***Partial Revisions to the Application Document for
Approval to Amend the Implementation Plan
Regarding the Handling of ALPS Treated Water
[Overview]**

July 15, 2022

Tokyo Electric Power Company Holdings, Inc.

4-6. Major Changes and additions

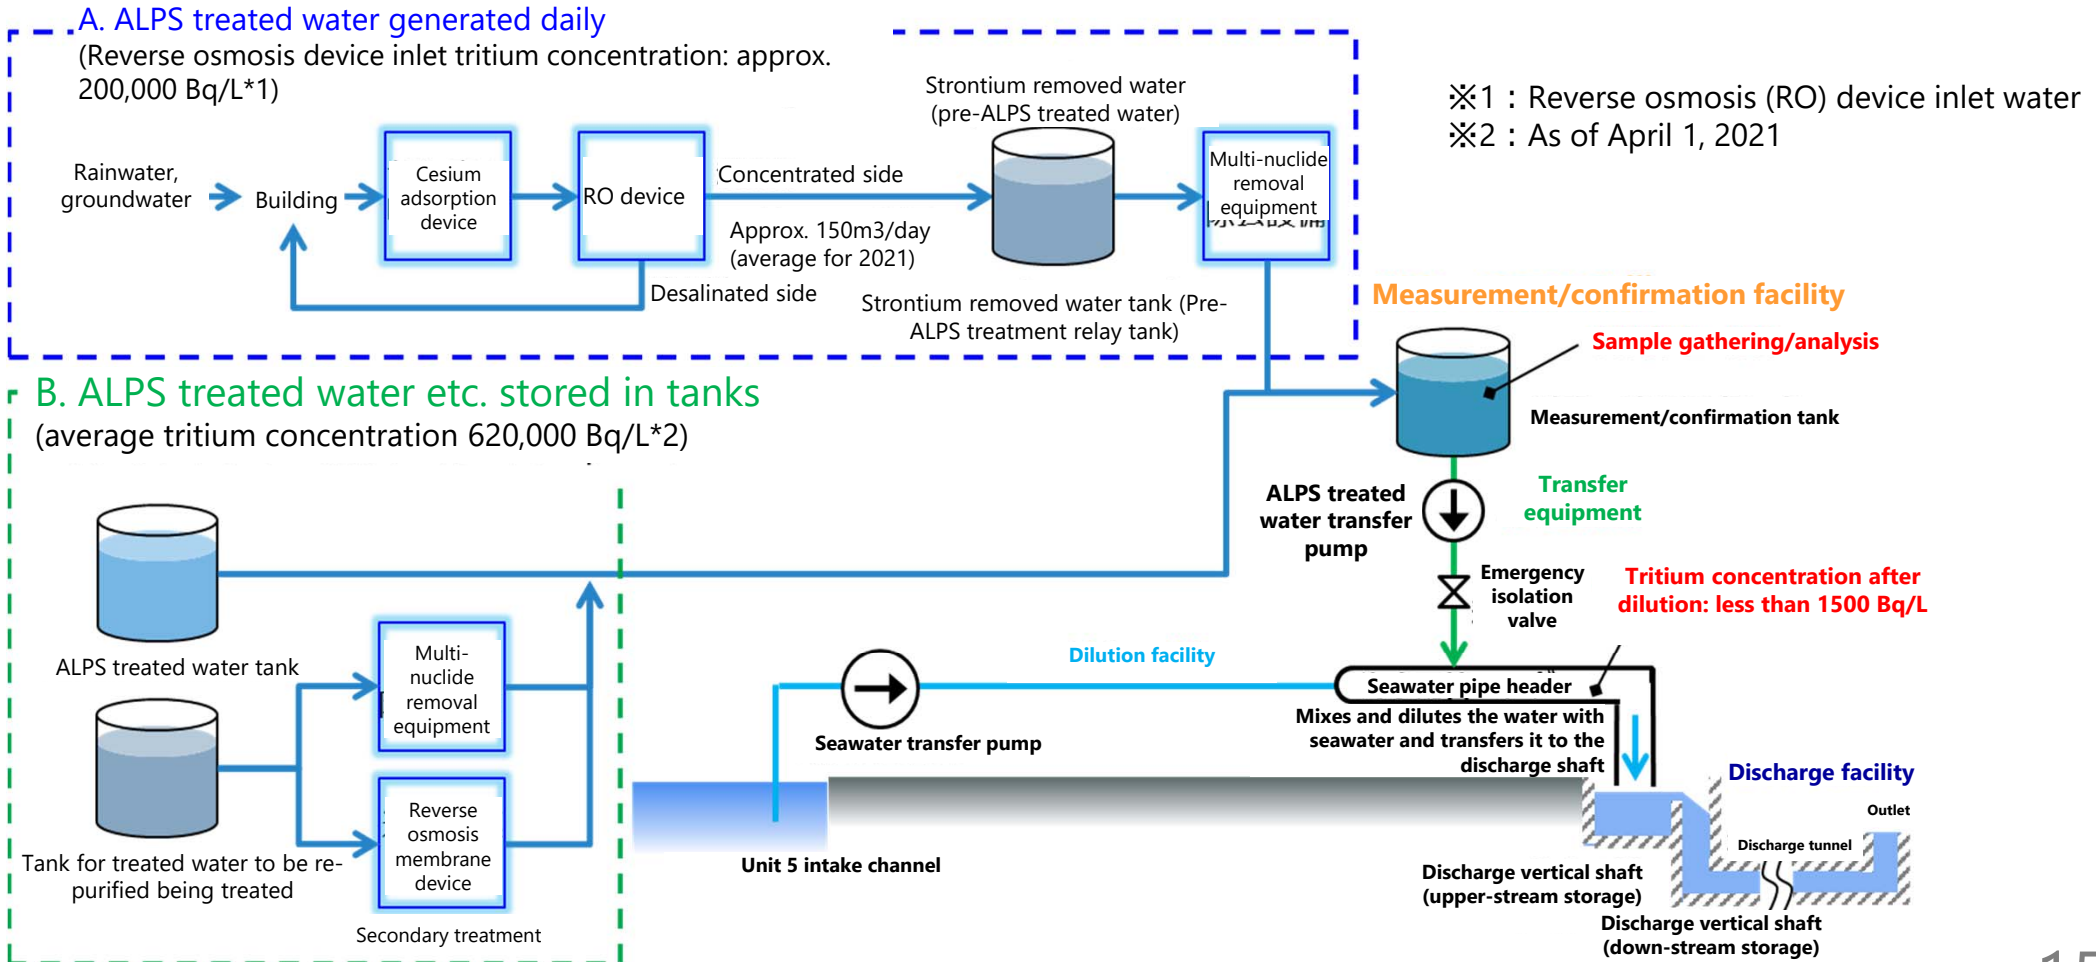
- Management of the annual amount of tritium discharged
 - ALPS treated water to be discharged is comprised of A. ALPS treated water generated daily, B. ALPS treated water, etc. stored in tanks. The basic policy is to discharge ALPS treated water starting with the water with the lower tritium concentration. The application was amended to include the tritium water management policy whereby ALPS treated water is discharged (A below) and then ALPS treated water is discharged at amounts that do not exceed 22 trillion Bq/year (B below).
